Access Compliance Report

Public Rights-of-Way

(Curb Ramps)

Intersection ID: 14859	Main Street: BRIAR_CREEK_RD	Cross Street: COLONNADE_DR	Location: E
ADA ID: 770F1DD27700	Ramp Type: Perp	Initial Pass/Fail: Fail	Overall Compliance: No
Codes/Mitigation Info/Possible Solution		Field Measurements/Component Compliance	
Severity Score: 58.75

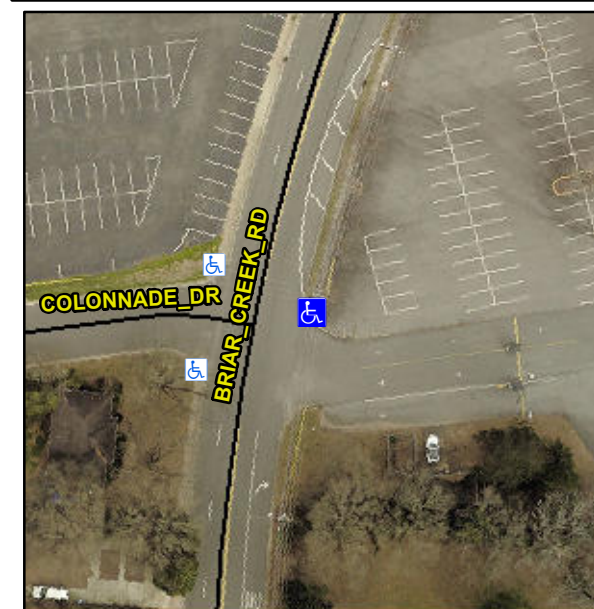
Not Found, R304.5.1, R304.2.2, R304.5.3

Compliance	Description	Data	Compliance	Description	Data
N/A	Ramp Length (in)	44.0	No	Ramp Slope (%)	13.5
No	Ramp Width (in)	36.0	No	Ramp XSlope (%)	7.8
N/A	Flare Type LT	N/A	N/A	Flare Type RT	N/A
N/A	Flare Slope LT (%)	N/A	N/A	Flare Slope RT (%)	N/A
N/A	Flare Traversable LT?	N/A	N/A	Flare Traversable RT?	N/A
N/A	Landing Length (in)	N/A	N/A	DWS Provided?	N/A
N/A	Landing Width (in)	N/A	N/A	DWS Contrast?	N/A
N/A	Landing Slope (%)	N/A	N/A	DWS Length (in)	N/A
N/A	Landing X Slope (%)	N/A	N/A	DWS Full Width?	N/A
N/A	Landing Curb? (Y/N)	N/A	N/A	DWS Offset (in)	N/A
N/A	Shared Landing?	N/A			
N/A	Gutter Ponding?	N/A	N/A	Gutter Slope (%)	N/A
N/A	Gutter Lip Ht (in)	N/A	N/A	Gutter X Slope (%)	N/A
N/A	Painted X Walk1?	No	N/A	Painted X Walk2?	N/A
	X Walk 1 Direction	To NW		X Walk 2 Direction	N/A
N/A	X Walk 1 Width (in)	N/A	N/A	X Walk 2 Width (in)	N/A
	X Walk 1 Slope (%)	1.4		X Walk 2 Slope (%)	N/A
	X Walk 1 X Slope (%)	5.5		X Walk 2 X Slope (%)	N/A

Remove & Replace Entire Ramp.
